KEENE PLANNING BOARD
Council Chambers, Keene City Hall
June 22, 2026
6:30 PM

STAFF REPORT – CONTINUED PUBLIC HEARING

ELM CITY COMMONS

Figure 3. Snippets showing the previous proposed design for the street-facing building facades and the updated design.

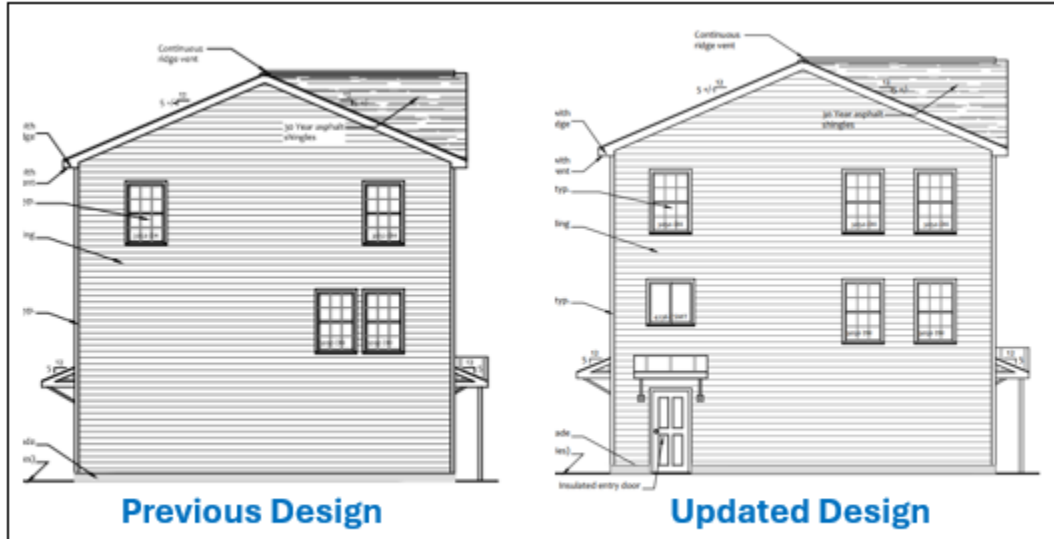
In response to these comments, the applicant has submitted revised architectural elevations that include a door on the gable end facing the street with a small roof above. In addition, two more windows were added along these facades and the window locations were re-aligned to be more regular (Figure 3). The applicant has noted that they intend to bring several concept plans to the June Board meeting to explain why other building orientations, such as a north-south orientation, were not chosen for the site layout.

FILE: 4200SP00B.dwg	PROJ. NO. 4200.00	SHEET: LS-1
---------------------	-------------------	-------------

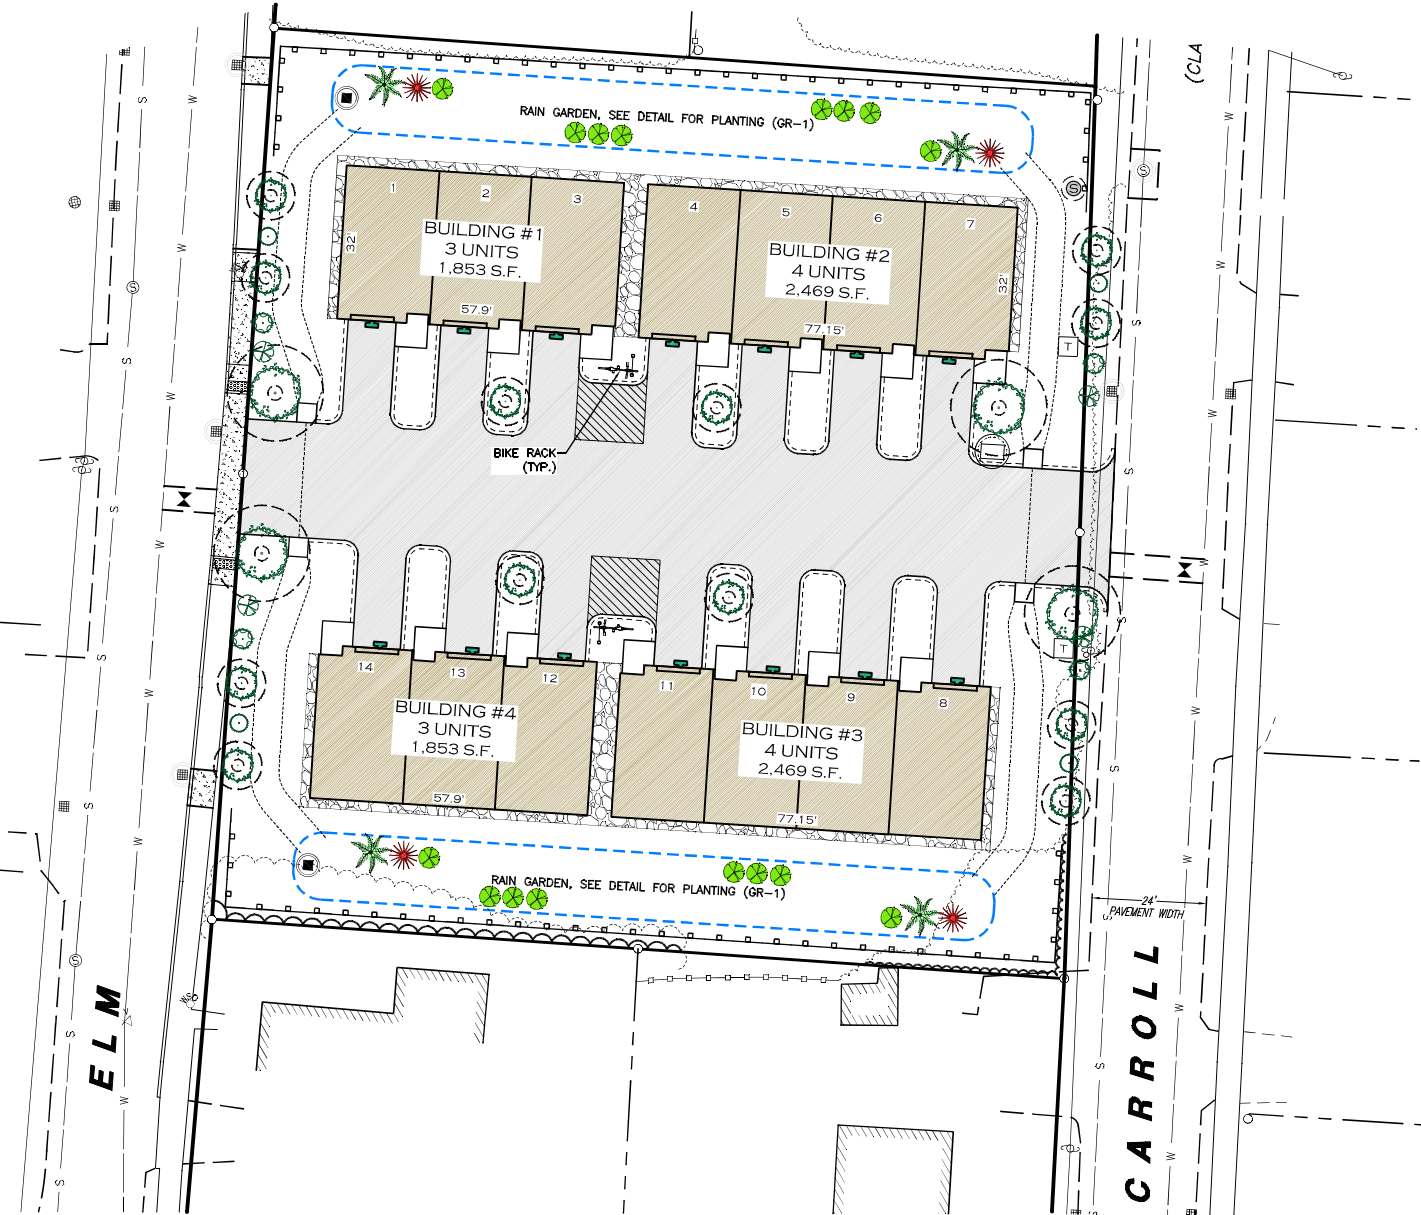
- 561
- 562 1. Submittal of a revised site plan that shows the installation of one, 3-inch caliper American
563 Linden tree and one 3-inch caliper Swamp White Oak in place of the proposed Red Maple
564 trees that are currently shown on the plan.
 - 565 2. Addition of a note on the plan stating that the Best Management Practices described in an
566 NH DOT Publication shall be utilized during construction.
 - 567 3. Submittal of a new design for the rain garden that preserves three mature trees on the north
568 end of the site which were previously proposed to be removed.
 - 569 4. Submittal of a salt reduction plan that includes operation protocols to prevent unwanted
570 chemical going into the rain garden.
 - 571 5. Submittal of a revised site plan showing pervious pavement for the rear parking spaces.

- 692 d. Submittal of a revised site plan that shows the installation of one 3-inch caliper
693 American Linden tree and one 3-inch caliper Swamp White Oak in place of the two
694 proposed red Maple trees.
